Subject: 145<sup>th</sup> Subarea Addendum to the DEIS

City of Shoreline

Thornton Creek and West Lake  
Washington Basins  
Characterization Report

**RE: City of Shoreline Paramount Open Space Wetland and Stream Assessment and Comments on the 145<sup>th</sup> Light rail Area DEIS and Subarea proposal.**

Figure 5: Twin Ponds and Paramount Park Wetlands and Streams

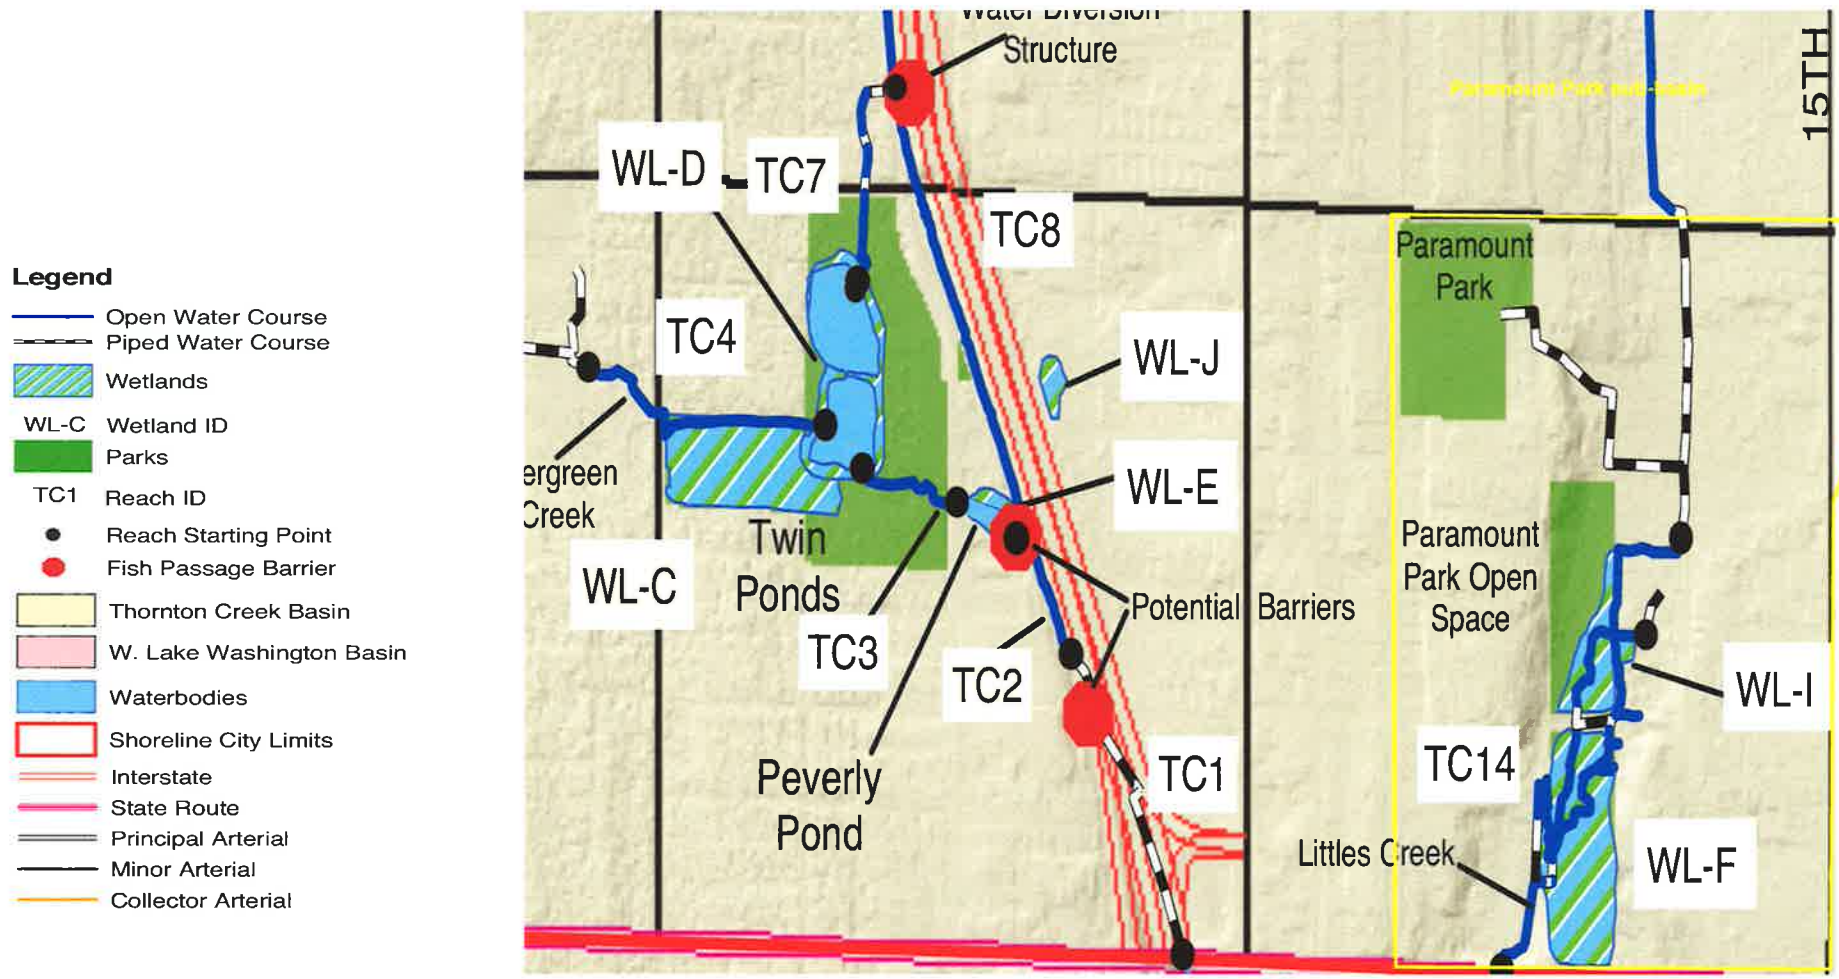
The two ponds and associated Wetland WL-F on Figure 5 were enhanced and/or constructed by local volunteers under a Water Quality Block Grant awarded by King county Department of Natural Resources prior to the 2004 basin characterization report. These areas are now well established and the plantings installed back in the early 2000's are now well established. Photos on photo sheet 6 of the attached photos show some examples of this area.

Little's Creek (Subbasin TC-C – Figure 3) flows through Paramount Open Space through segment TC14 mapped on Figure 5 as a tributary to Thornton Creek. The aerial photograph evidence documented in the City's Thornton Creek Characterization Report states that it flowed to Jackson Park in an open stream prior to the 1940's (Tetra Tech 2004). Much of this Creek has been piped from residences west of NE 174<sup>th</sup> Street and 14<sup>th</sup> Ave NE with another tributary that is now also flowing from a culvert. Beginning at 12<sup>th</sup> Ave NE, the creek (Figures 5 and 6) come out of a pipe and flow west to the Park and then jog south where the tributary splits into two. The western arm, which is the main channel of Little's

Creek, flows through Wetland WL-1 (2004 inventory, Figure 5) and a drainage tract with landscaping; and the eastern arm flows through on the edge of Wetland WL-L and through Wetland WL-F (also Figure 5 where it enters the pond and wetland enhancement area identified above supplying the wetlands, seeps back into the second pond via small channels described above and then flows west into the main channel of Littles Creek. The stream through the Park is generally still in good condition with sufficient bank vegetation and sparse armoring and fair pool frequency. Gravel and quarry spall is present in the south end of the reach but overall this segment is the ONLY one of the three segments of Thornton Creek within the City of Shoreline that was given a "fair" rating when assessed (Tetra Tech 2005). It is imperative that the City do all it can to maintain the integrity of these tributaries should the new zoning become reality. Increasing residence density on the east side of the Park would be in the direct path of many of these channels and no additional piping should be allowed. It should be noted that the DEIS states that Littles Creek lies ½ mile from the Proposed Light Rail Station, but actually it is only ¼ of a mile.

**Figure 6: Paramount Park Wetlands and Streams Mapping, City of Shoreline GIS 2016.**

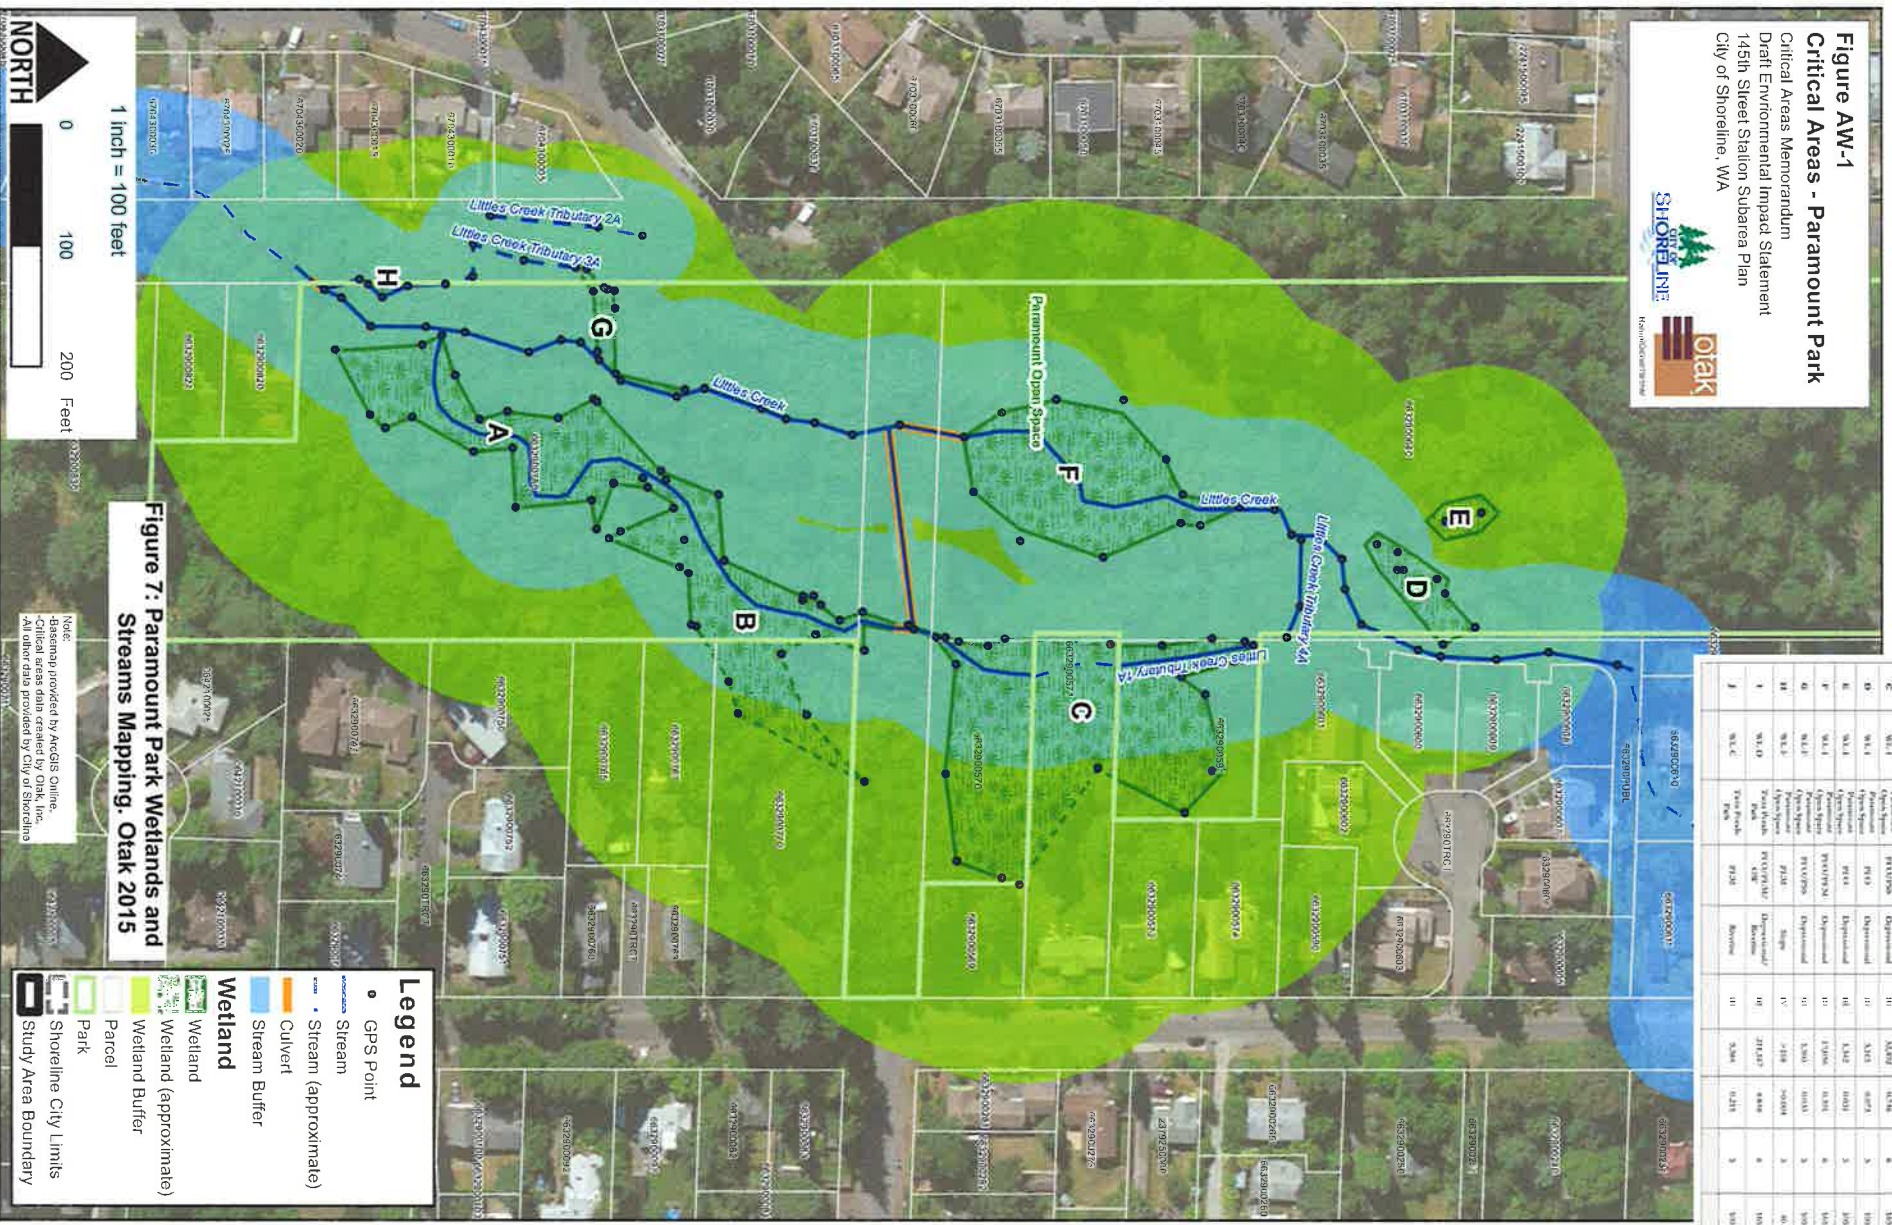
part of the park, (Figure 6 arrows showing where additional wetland was found; Figure 8 photo map and Photos 21-25). We also found more wetland in the northeast corner of the Park and associated residences that are not shown on the Otak map (Figure 6 arrows showing where additional wetland was found; Figure 8 photo map and Photos 1-10). And more wetland in the central part of the park between Wetland F and Wetland C such that these two wetlands are actually one wetland system (Photos P1, P2, P18, and P19). Additionally, many of the residences on the east side of the Park along 12<sup>th</sup> Avenue NE had wetland continuing into their western back yards abutting the Park (Figure 6 arrows showing where additional wetland was found; Figure 8 photo map and Photos 12-20). Much of this area was also not included as wetlands mapped by Otak. Approximate GPS locations of wetlands found during our February reconnaissance are shown on Figure 8 where the photo pins are located and on Figure 6 where the arrow points indicate locations where both photos and GPS points were taken in areas that were wetlands.. The arrows shown on Map 6 do not show a formal delineation map. It is indicating areas that met wetland criteria and which were not identified on the Otak map as being wetland. A word about the photos included: The photos show characteristics about the ground conditions – either the vegetation prevalent (which is usually wetland species for the wetland shots) or the soils conditions (again showing wetland soils), or standing water indicating the area has wetland hydrology. When the shots are of upland they indicate this.

The Otak reconnaissance wetland map is also displayed as a layer on the City's Wetland map as a layer that is shown as either a blue or yellow polygon/series of polygons on Figure 6. as the with Wetland III having a much reduced footprint of wetland WL-I and the red pattern with a much reduced footprint over the previous delineation also shown as the blue shaded pattern on Figure 6.

In the 2000 and 2004 Thornton Creek reports by the City of Seattle and Tetra Tech for the City of Shoreline including stream inventory (Appendix A May 2004), and the City's own GIS database (Shoreline online GIS Mapper) all show the streams to be mapped as shown on Figures 5 and on Figure 6, (the overall outline including both the blue and black segments). Figure 6 also shows the seam/creek reconnaissance identified by Otak in their December 2015 reconnaissance as the blue segments with the detailed stream reconnaissance shown on Figure 7.

The drainages (streams and creeks) mapped in the Park by Otak (Figures 6 and 7) include some omissions that have been added back as the black lines on the City's GIS database (Figure 6). We observed these creeks/drainages are still present when we performed our reconnaissance on January 29<sup>th</sup>, 2016 (Photos P8, P9, P11, P17, P20, P23, P24, P21, and P25). Little's Creek is the main tributary to Thornton Creek through the park but there are many other tributaries, wetlands, ponds and connecting channels that are also present (See Figures 5 and 6). Some of the channels are now piped, especially the main channel that passes through a culvert under the gravel road the bisects the Park from north to south (photo P17).
